Meeting Agenda Plat Committee

Monday, August 10, 2026

1. [KPB-7890](#) Pioneer Vista Unit No. 6 Young Subdivision; KPB File 2025-135
Mullikin Surveys / Young, Martin-Young
Location: Herndon Drive & Svedlund Street
City of Homer

KPB File 2025-135

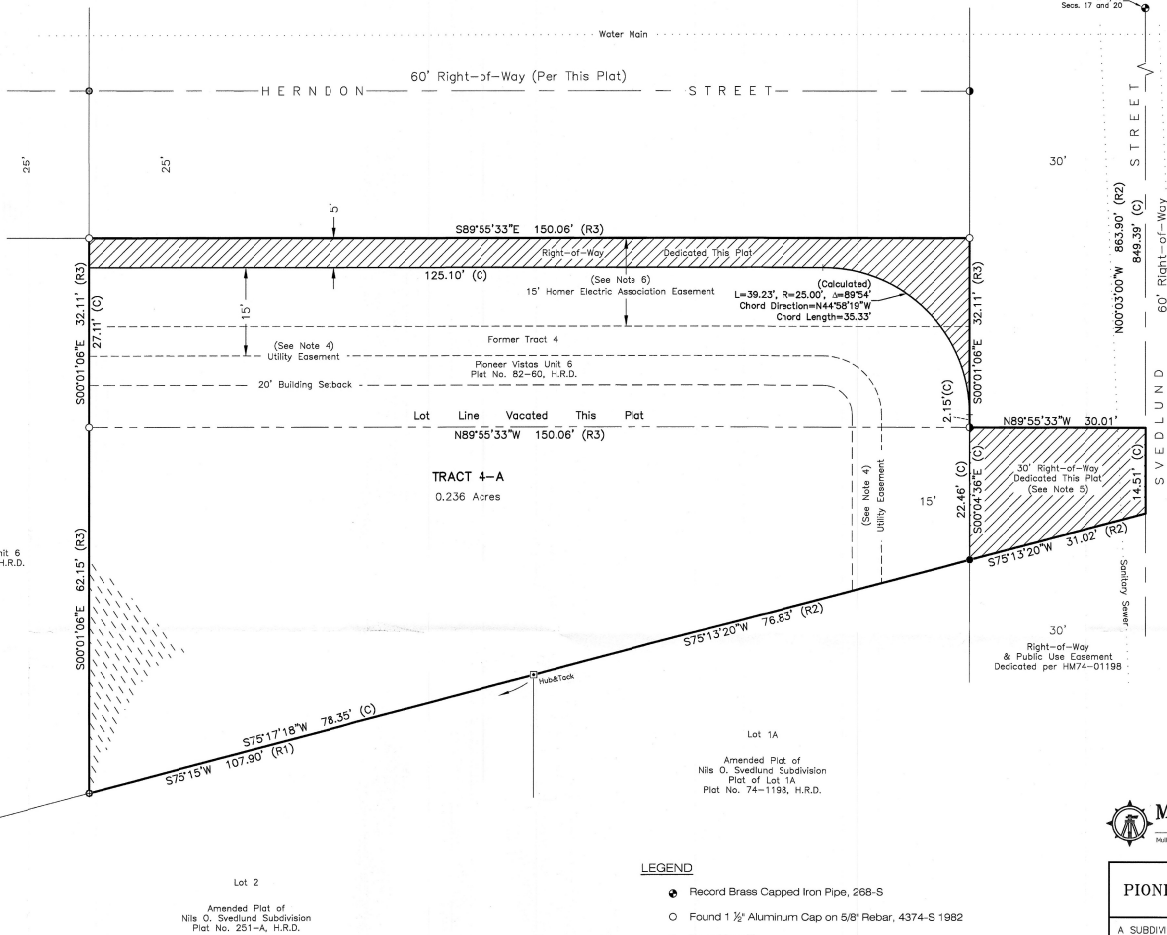
The plat was previously postponed pending review of associated rights-of-way. The City of Homer Planning Commission reviewed the plat on May 6, 2026, and granted conditional approval. Conditions include:

1. Dedicate the 30' Svedlund Street right-of-way.
2. Dedicate the northern 5' of Pioneer Vista Unit #6 Tract 4 as right-of-way. The Herndon Drive right-of-way shall be 60' total width.
3. The Herndon Street note shall be revised to Herndon Drive.

Per KPB 20.30.250, building setback requirements within cities are governed by municipal zoning. **Staff recommends** the applicant confirm with the City of Homer whether the 20-foot building setback should remain on the plat and provide confirmation with the next final plat. submittal

A 15-foot easement for electric lines and/or telephone lines was granted to HEA (Volume 143, Page 550, HRD). This easement has been depicted and added as plat note 6.

Addressing Review	Reviewer: Pace, Rhealyn Affected Addresses: 3927 SVEDLUND ST Existing Street Names are Correct: No List of Correct Street Names: HERNDON DR, SVEDLUND ST Existing Street Name Corrections Needed: PLAT LIST HERNDON ST SHOULD BE HERNDON DR All New Street Names are Approved: No
-------------------	--

- o Modify the Plat Approval date to August 10, 2026
- o Add “aka Sonja Martin-Young” within under the signer in the Certificate of Ownership and Dedication
- o Remove plat note 9, no wetlands identified per KWF Wetlands Assessment.
- o Give distance from northeast corner of Tract 4 to pin found to the north.

TO: Homer Planning Commission
FROM: Ryan Foster, City Planner
DATE: May 6, 2026
SUBJECT: Pioneer Vista Unit #6 Young Replat

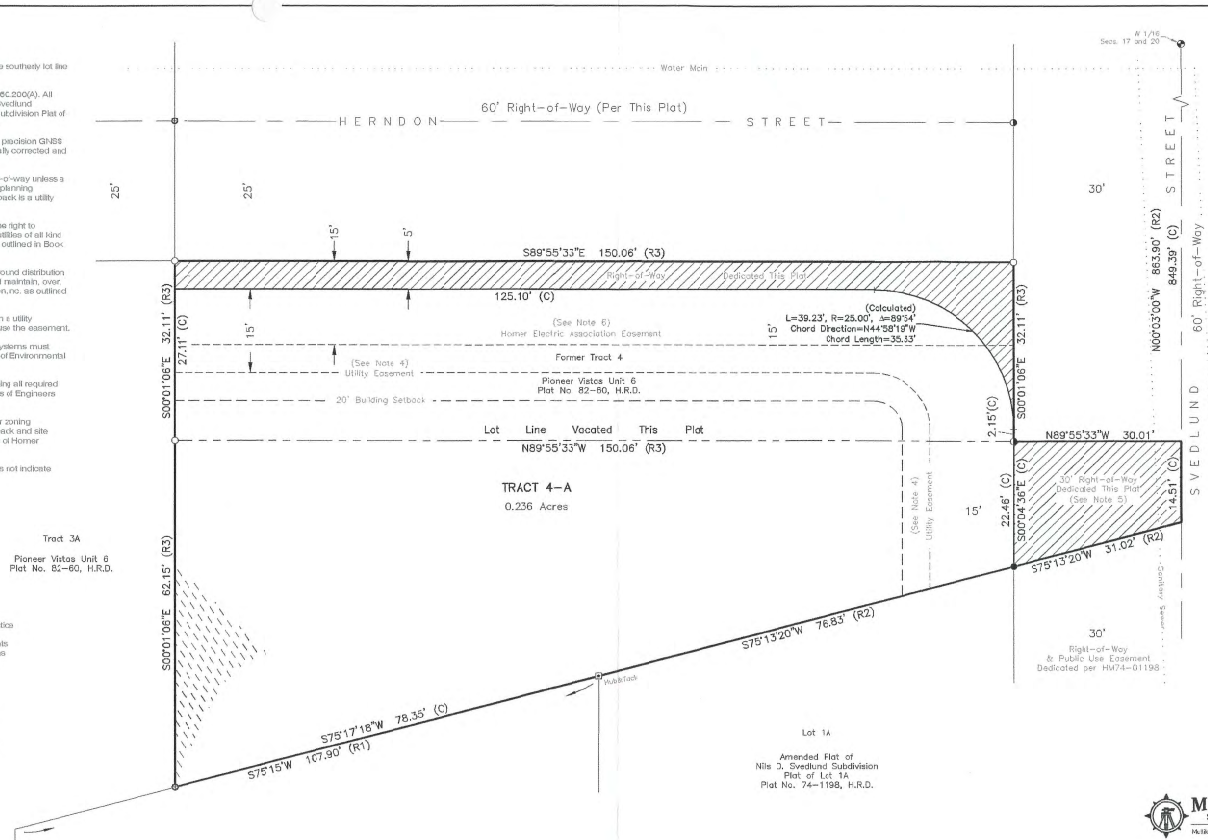
Staff Response: The plat does not meet these requirements. The Herndon Street note shall be revised to Herndon Drive.

Staff Response: The plat meets these requirements. A 30' portion of the Svedlund Street Right-of-Way shall be dedicated. The northern 5' portion of Unit #6 Tract 4 will be dedicated as part of the Herndon Drive Right-of-Way

Staff Response: The plat does not meet these requirements. The Herndon Street note shall be revised to Herndon Drive. The City of Homer has no objection to the 60' Herndon Drive Right-of-Way.

Staff Response: The plat meets these requirements. Apparent building setback encroachments will be removed with the lot line vacation.

1. Dedicate the 30' Svedlund Street Right-of-Way.
2. Dedicate the northern 5' of Unit #6 Tract 4 as Right-of-Way. The Herndon Drive Right-of-Way shall be 60' total width.
3. The Herndon Street note shall be revised to Herndon Drive.
